We first like to thank the reviewer for the comprehensive, fair and constructive comments. Please find our answers to the comments below. We marked the reviewers comments blue and our answers black.

We first like to thank the reviewer for the comprehensive, fair and constructive comments. Please find our answers to the comments below. We marked the reviewers comments blue and our answers black.

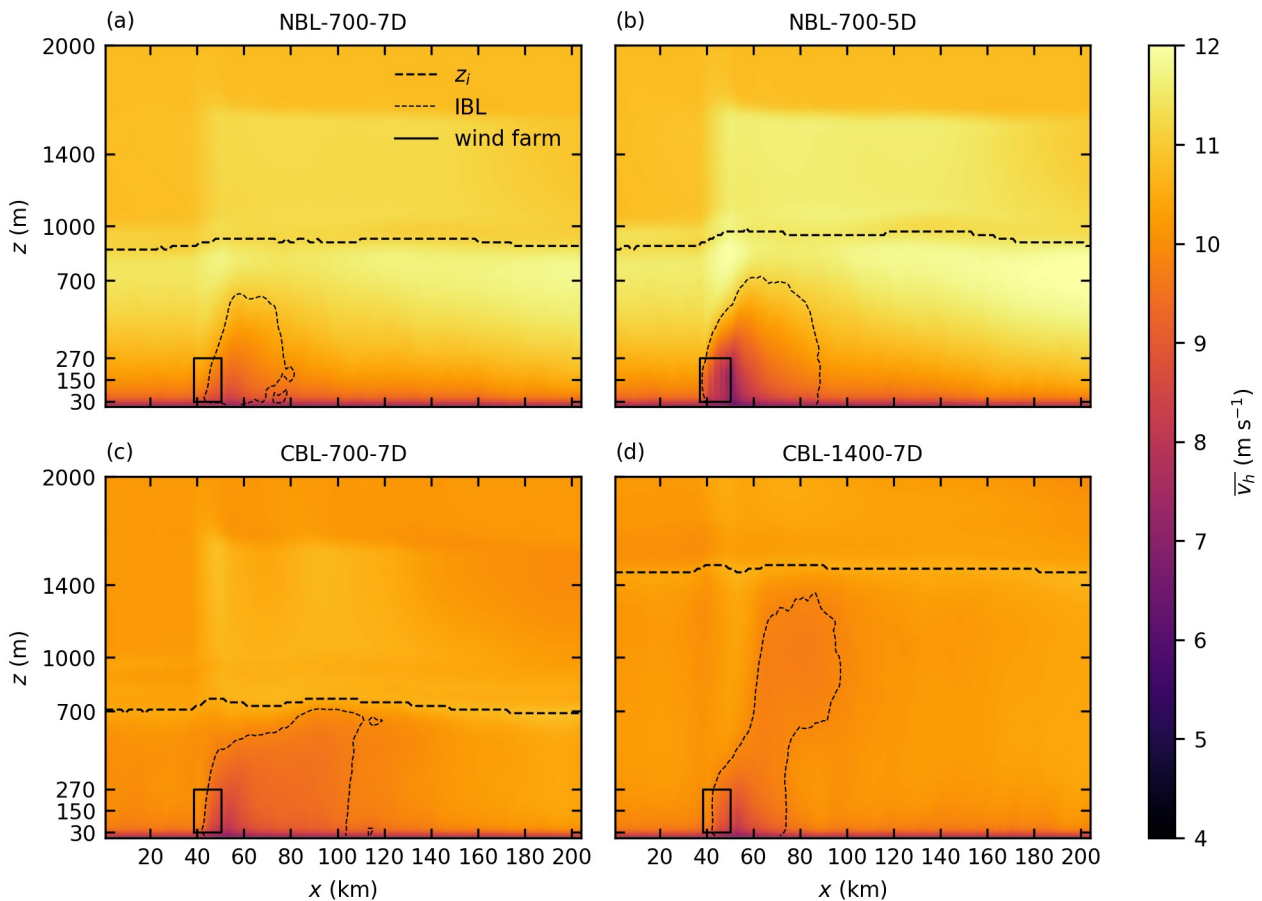
- Line 296: “The wake length and speed deficit of small wind farms (e.g. N-1 and N-2) is relatively unaffected by the BL height because the wind farm induced internal boundary layer does not reach the top of the BL.” Did you investigate the internal

boundary layer development? If not, how can you know that this is the reason? It would be interesting to add IBL development to figure 7 (and extend the analysis to small wind farms as well, see below) to support this hypothesis.

We now included IBL-lines in Figure 7 and added a new figure with vertical cross sections through a small wind farm ( $y = 50$  km), that shows the IBL behaviour (Figures shown later under reviewers point 2). We rephrased line 296 ff like this:

"The wind speed deficit and the wake length of small wind farms (e.g. N-1, N-2 and N-3) is relatively unaffected by the BL height because the wind farm induced internal BL does not reach the inversion layer (NBL cases) or only reaches it several 10 km downstream of the wind farm trailing edge (CBL cases), cf. Fig. 7.5\_new. Consequently, the BL height only affects further wind speed recovery (e.g. to 9.5 m/s) in the far wake of small wind farms. For example, the wind speed recovery from 9 to 9.5 m/s in the wake of N-2 takes longer for the case CBL-700-7D (~40 km) than for the case CBL-1400-7D (~15 km), cf. Fig 4 c and d."

TKE and SGS-TKE at hub height in the wake 3D behind the turbine

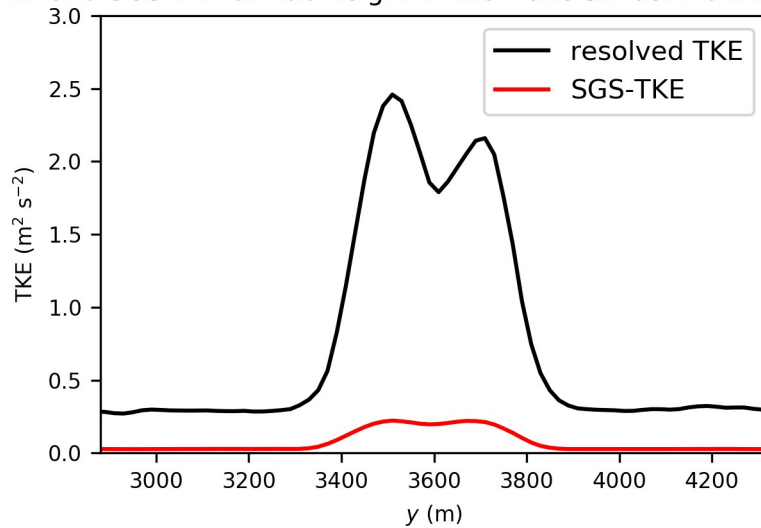
L386, the TKE does consider the subgrid scales. Since the resolution is relatively coarse to resolve the flow around the rotors, a sizable part of the TKE is potentially found within the subgrid scales. Please provide an argument regarding why only resolved scales should be considered in this analysis.

Resolved and SGS-TKE is displayed in the following figures and justifies that the SGS-TKE has no significant contribution here.

“The SGS-TKE is neglected, because it is smaller than 10 % of the resolved TKE, inside the wind turbine wakes at a distance of 3D or more.”
